Re: Turkey Point Units 3 and 4
Docket Nos. 50-250 and 50-251
Response to NRC Reactor Systems Branch Request for Additional Information
Regarding Extended Power Uprate License Amendment Request No. 205

RESPONSE TO NRC REACTOR SYSTEMS BRANCH REQUEST FOR
ADDITIONAL INFORMATION REGARDING EXTENDED POWER UPRATE
LICENSE AMENDMENT REQUEST NO. 205

SRXB-3.3.1 RAI SRXB-2.3.1 (ADAMS Accession No. ML11263A204) requested validation of the departure from nucleate boiling (DNB)-protective OTAT trip setpoint by means of a demonstration depressurization safety analysis. By letter dated September 30, 2011 (ADAMS Accession No. ML11276A080), the licensee provided the requested information, which was based on the conservative DNB analysis of an inadvertent safety valve opening. This is conservative because a safety valve has a higher relief capacity than the power operated relief valve (PORV). Figure SRXB-2.3.1-5 plotted the pressurizer level associated with this transient. The plot indicated a very sharp pressurizer surge that, if extrapolated, would reveal the pressurizer filling rather quickly.

Figure SRXB-3.3.1-4: Pressurizer Volume vs. Time

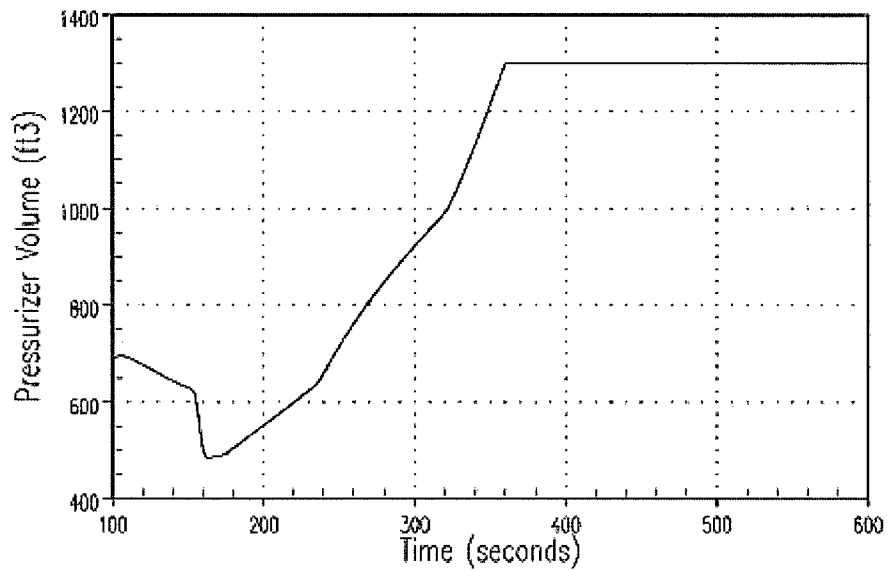
The inadvertent PORV opening is an anticipated operational occurrence (AOO), and the information plotted in Figure SRXB-2.3.1-5 brings forth the concern that an inadvertent PORV opening could result in a pressurizer overflow condition. Such a condition could lead to an inability to isolate the PORV, resulting in a condition similar to a small break LOCA. This would not be an acceptable end result for an inadvertent opening of a PORV.

Supplement the response to SRXB-2.3.1 to demonstrate that the pressurizer does not overflow. To address this concern, the staff recommends supplementing a thermal-hydraulic analysis of the reactor coolant system response to an

inadvertent PORV (or, if additional conservatism is sought, a safety valve) opening with maximum safety injection with the following information. Identify the control-grade mitigating systems, structures, or components (SSCs), if any, that would terminate this event, and indicate their actuation signals and time of actuation. Also identify the time of operator notification of the inadvertent PORV opening, and the actual signals that would notify the operator. Finally, discuss what operator actions would terminate this event, and discuss how long the operator would take to perform these actions. The thermal-hydraulic analysis should be of an unmitigated event, and it should run long enough to indicate the time from event initiation to pressurizer overfill.

Based on the results of the representative analysis cases considered, the minimum time to pressurizer filling is approximately 4 minutes. Table SRXB-3.3.1-2 provides the sequence of events for the limiting case (i.e., fastest to fill). The RCS pressure remains low such that the Pressurizer Safety valves (PSVs) are not challenged. Figures SRXB-3.3.1-1 through SRXB-3.3.1-4 provide the transient plots of key parameters. Note that the times presented include 100 seconds of steady state operation prior to the initiation of the transient. This steady state condition has been removed from the figures (i.e., the figures start at 100 seconds).
